**Seattle
Design
Commission**

MINUTES OF THE MEETING

20 February 2003

Northgate Library, Parks, and
Community Center Site Plan
Southwest Community Center Expansion
Yesler Community Center
Retreat Follow-Up
Lake City Parking Garage
Park 90-5 Building

Yesler Community Center site plan.

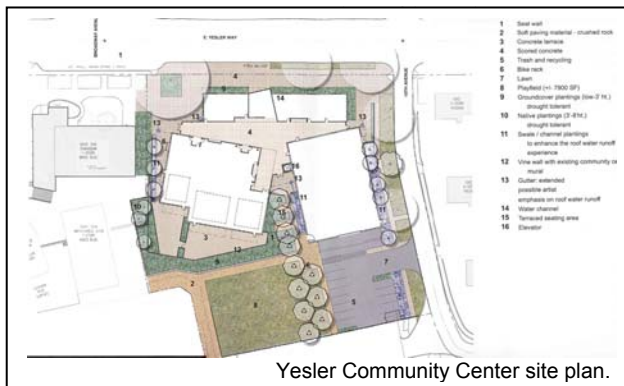
- The Design Commission recognizes the care taken in the massing of the building and the design of the entrances;
- appreciates the way in which the building is fit to the contours of both the neighborhood and the site, and recognizes the difficulty in doing so;
- appreciates the effort put into placing the parking under the gym and recognizes that there are costs related to that;
- applauds the team's efforts to attain LEED Silver (?) standards for the building, especially the studies on lighting, which will greatly add to the

- use to the Blue Ring Strategy, and believes the intensive future development has been created;
- to more openness along Yesler Way and to think openings in the brick wall;

- large, significant trees on site and encourages locate for protection of those throughout the the damage is often done;
- the mechanical shed on the back side of the gym it might be expressed or integrated that are building and sensitive to pedestrians on the street;

- urges the team to look again at the grading, belvedere and large retaining wall in back, recognizing that this has the potential to be cut in future budgets and consider other ways to integrate usable flat, open space with the grade change rather than having a single, large vertical wall;

- also encourages proponents to design the grading on the south in a manner that fits with the delightful terrace character of the building massing; and
